# Access Compliance Report

## Public Rights-of-Way

### (Curb Ramps)

Intersection ID: 10019931	Main Street: ARDREY_KELL_RD	Cross Street: N/A	Location: NW
ADA ID: AAE58052B2EA	Ramp Type: Perp	Initial Pass/Fail: Fail	Overall Compliance: No
Severity Score: 25			
Codes/Mitigation Info/Possible Solution		Field Measurements/Component Compliance

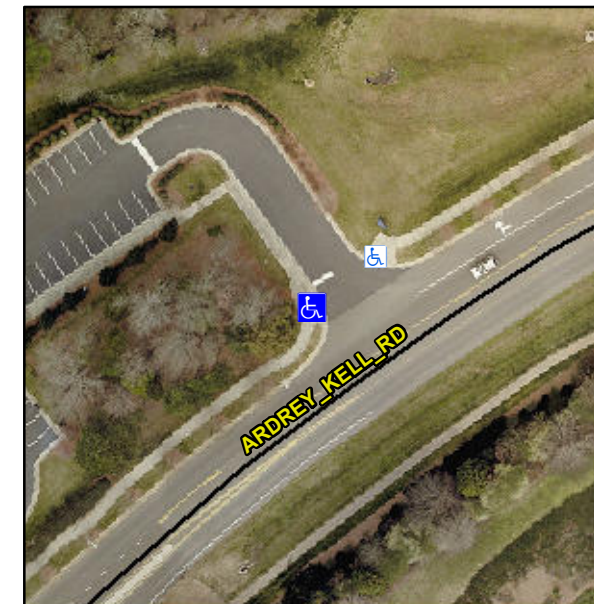
**Not Found, R304.5.3**

Compliance	Description	Data	Compliance	Description	Data
N/A	Ramp Length (in)	85.0	Yes	Ramp Slope (%)	8.2
Yes	Ramp Width (in)	48.0	No	Ramp XSlope (%)	7.5
N/A	Flare Type LT	N/A	N/A	Flare Type RT	N/A
N/A	Flare Slope LT (%)	N/A	N/A	Flare Slope RT (%)	N/A
N/A	Flare Traversable LT?	N/A	N/A	Flare Traversable RT?	N/A
N/A	Landing Length (in)	N/A	N/A	DWS Provided?	N/A
N/A	Landing Width (in)	N/A	N/A	DWS Contrast?	N/A
N/A	Landing Slope (%)	N/A	N/A	DWS Length (in)	N/A
N/A	Landing X Slope (%)	N/A	N/A	DWS Full Width?	N/A
N/A	Landing Curb? (Y/N)	N/A	N/A	DWS Offset (in)	N/A
N/A	Shared Landing?	N/A			
N/A	Gutter Ponding?	N/A	N/A	Gutter Slope (%)	N/A
N/A	Gutter Lip Ht (in)	N/A	N/A	Gutter X Slope (%)	N/A
N/A	Painted X Walk1?	No	N/A	Painted X Walk2?	N/A
	X Walk 1 Direction	To NE		X Walk 2 Direction	N/A
N/A	X Walk 1 Width (in)	N/A	N/A	X Walk 2 Width (in)	N/A
	X Walk 1 Slope (%)	3.2		X Walk 2 Slope (%)	N/A
	X Walk 1 X Slope (%)	3.6		X Walk 2 X Slope (%)	N/A

**Remove & Replace Entire Ramp.**
